SERVICE BULLETIN

1528

MODEL: Power Mac 6, 6A

SUBJECT: STOP SWITCH WIRE ASSEMBLY

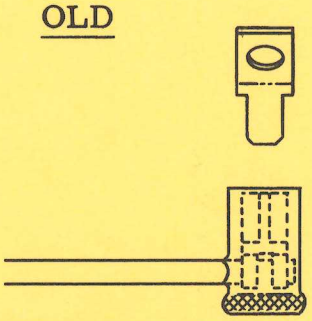
The switch end of the PM6 and PM6A stop switch wire assembly has been changed from a two-piece tab terminal to a simple closed end loop terminal as illustrated below:

This change prevents the switch wire from being pulled off during operation of the saw when sawdust and debris restricts the movement of the wire. When this happens, the engine cannot be shut off.

The length of the wire has been reduced from 4 1/2 in. to 3 3/4 in.

P/N 88435, Wire and connector
